APPLICATION NO.	FILING DATE	FIRST NAMED INVENTOR	ATTORNEY DOCKET NO.	CONFIRMATION NO.
10/598,351	08/07/2007	Luca Matteucci	78857.105418	2949
86528	7590	05/26/2010		
King & Spalding LLP 401 Congress Avenue Suite 3200 Austin, TX 78701			EXAMINER JONAITIS, JUSTIN M	
			ART UNIT 3752	PAPER NUMBER
			NOTIFICATION DATE 05/26/2010	DELIVERY MODE ELECTRONIC

Office Action Summary	Application No. 10/598,351	Applicant(s) MATTEUCCI ET AL.	
	Examiner JUSTIN JONAITIS	Art Unit 3752

DETAILED ACTION

U.S. Patent # 6,260,775 to Lambert et al. : Figure 5

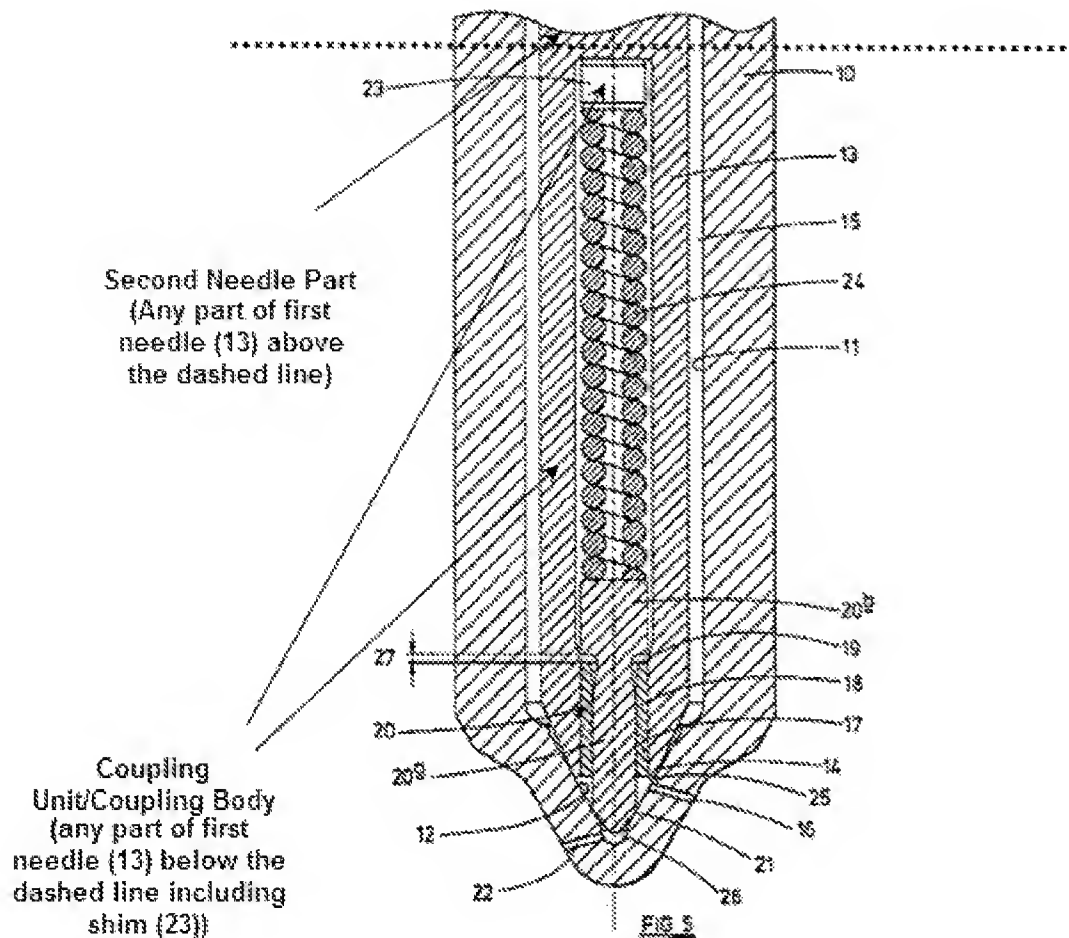
The figure below is reproduced from the Lambert reference in order to show examiner's interpretation.

In re claims 1-2, 5-6, and 9, Lambert discloses a fluid injector comprising an actuator unit (column 6, lines 24-33 disclose an actuator), a cartridge (nozzle body (10)) comprising a recess (bore (11)) which on one of its open ends forms an injection nozzle (outlet opening (22)) forms the injection nozzle).

The device disclosed by Lambert further includes a needle comprising a first and second part (second needle (20) and portion of first needle (13) above the dashed line in figure 5 above respectively) with the first part being inserted into the recess and closing or opening the injection nozzle depending on the position of the first part, wherein the second part is coupled to the

actuator unit on one of its free ends (column 6, lines 23-33) and being coupled to the first part via a coupling unit comprising a coupling body (portion of first needle (13) below the dashed line including shim (23)), which is arranged in positive connection to the first part (via tubular sleeve) and joined (the second needle part and coupling unit are joined together to form one single unit and therefore the interpretation above where the second needle part being the portion of first needle (13) above the dashed line and the coupling unit being the portion of the first needle (13) below the dashed line from one integral piece, first needle (13)) wherein the coupling unit forms a spring rest (Shim (23) has spring (24) sitting on it), that urges the needle towards the position in which the injection nozzle is closed (column 5, lines 50-60).

The device further includes a receptance (enlarged region (20b)) formed in the first part and fixes a keeper (tubular sleeve (18)) in axial direction relative to the needle, and the coupling body having a recess (drilling (17)) through which the first part protrudes and which takes in the keeper such that the keeper fits substantially tightly within the recess to substantially prevent any radial movement of the keeper and first needle part relative to the second needle part [column 3, lines 41-43 & 54-56], the actuator (not shown), second needle part, and first needle part are arranged end-to-end in that order along an axial length of the fluid injector such that the movement of the actuator unit acts on the second part of the needle, which in turn acts on the first part of the needle to move the first part of the needle.
